BEFORE THE MERIDIAN CITY COUNCIL

IN THE MATTER OF THE)	
REQUEST FOR FINAL PLAT	
CONSISTING OF FIVE (5)	CASE NO. FP-2023-0021
BUILDING LOTS AND THREE (3)	
COMMON LOTS ON 11.46 ACRES	ORDER OF CONDITIONAL
OF LAND IN THE R-15 ZONING	APPROVAL OF FINAL PLAT
DISTRICT FOR MODERN	
CRAFTSMAN AT FRANKLIN.	
)	
BY: BAILEY ENGINEERING)	
APPLICANT)	
)	
)

SUBJECT: Modern Craftsman at Franklin – FP

FP-2023-0021

B. Final Plat

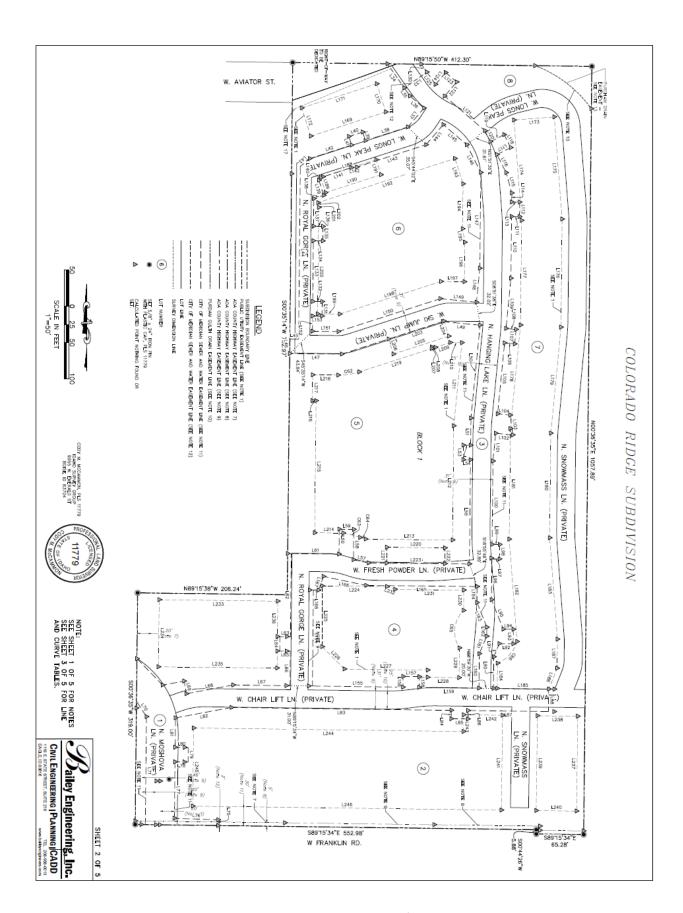
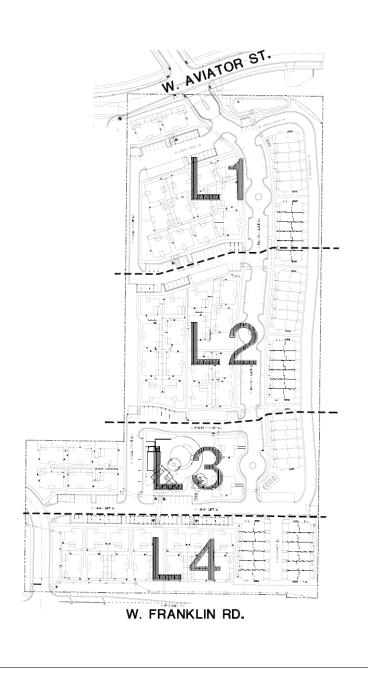
- 3. Prior to submittal for the City Engineer's signature, have the Certificate of Owners and the accompanying acknowledgement signed and notarized.
- 4. The final plat shown in Section V.B, prepared by Bailey Engineering, Inc., stamped by Cody M. McCammon, shall be revised prior to signature on the final plat by the City Engineer, as follows:

- a. Notes #11-15 and 17: Include the recorded instrument numbers of the noted easements.
 - b. Widen the sidewalk to 6-feet along W. Aviator St. in accord with preliminary plat condition #2.1d and Street Section C in the TMISAP, unless an alternative street section is approved by ACHD.

- c. Remove "N. Moshova Ln. (Private)" from the plat as it's not an approved private street and should not be named. Include a note for ownerhip and maintenance purposes that defines the use of the lot as a drive aisle.

- d. The Professional Land Surveyor's stamp shall be signed and dated.
 - e. Graphically depict and label the easement on Sheet 2 that's referenced in Note #13 for the private street ingress/egress and cross-access easement.

- f. A cross-access/ingress-egress easement shall be granted to the property to the west at 4610 W. Franklin Rd. (Parcel #S1210336377) for access to the drive aisle via W. Franklin Rd. located along the west property line per preliminary plat condition #2.5.

C. Landscape Plan (date: 2/27/24)

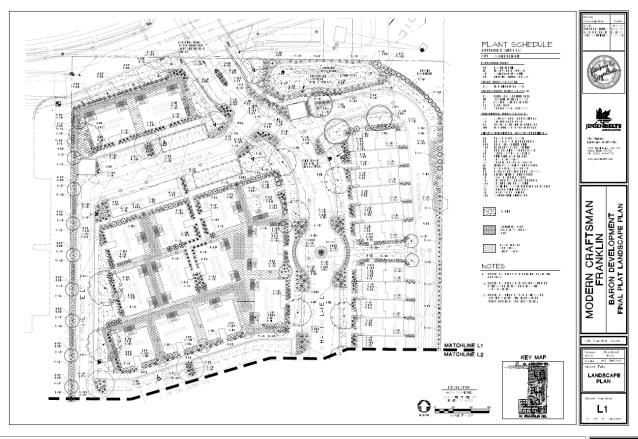
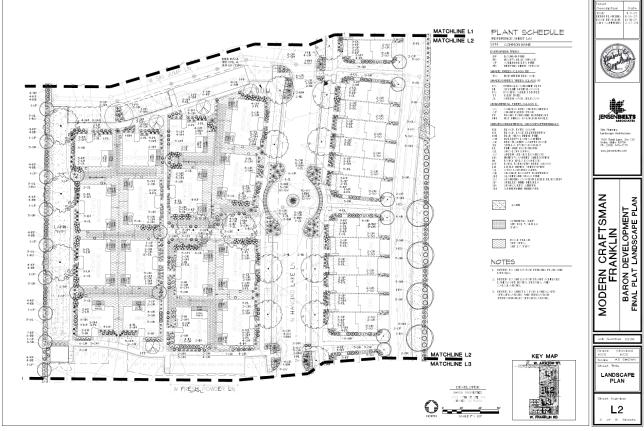
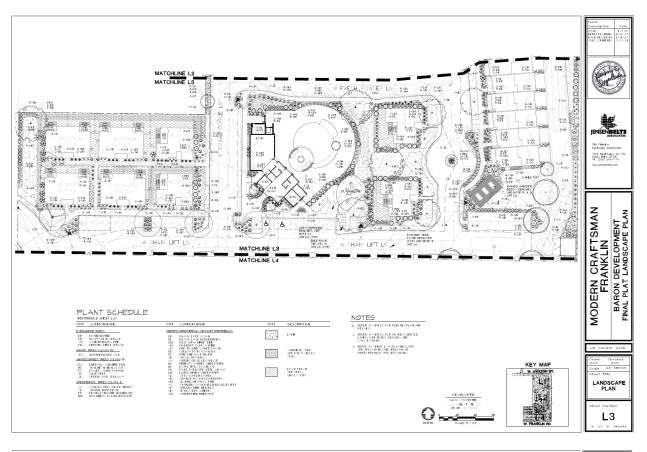
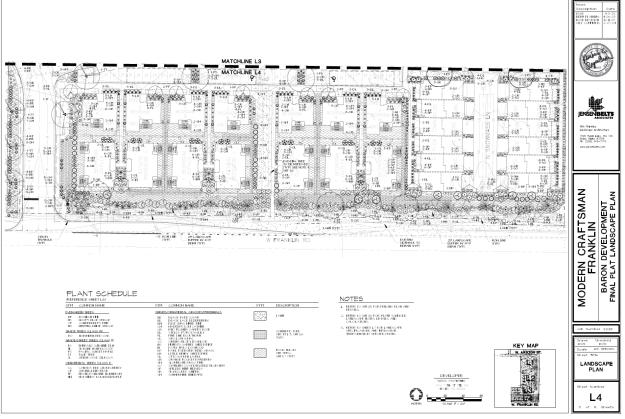
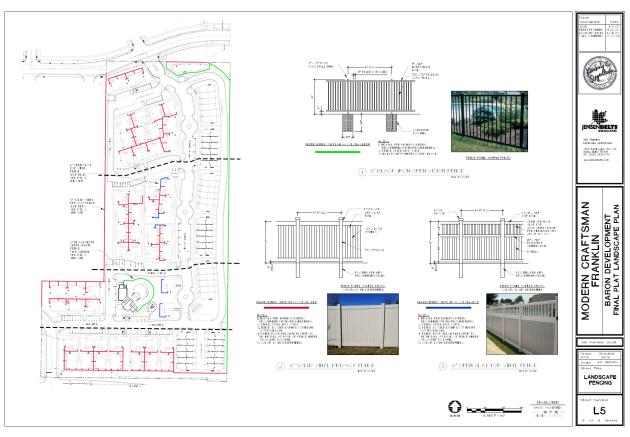
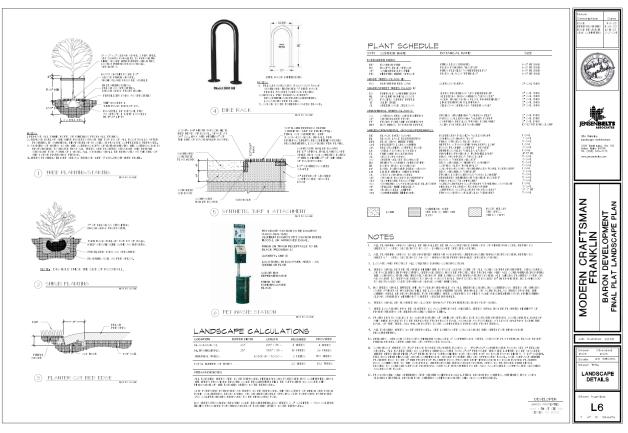
- 5. The landscape plan shown in Section V.C, prepared by Jensen Belts Associates, dated 2/27/24, shall be revised prior to signature on the final plat by the City Engineer, as follows:

- a. Widen the sidewalk to 6-feet along W. Aviator St. in accord with preliminary plat condition #2.1d and Street Section C in the TMISAP, unless an alternative street section is approved by ACHD.

- b. The rock mulch area within the 25-foot wide street buffer along W. Franklin Rd. shall be at least 70% covered with vegetation at maturity with mulch used under and around the plants as set forth in UDC 11-3B-5N.

- c. The berm within the street buffer along Franklin Rd. shall have no less than a 4:1 slope; include a detail of the berm that demonstrates compliance with this standard.
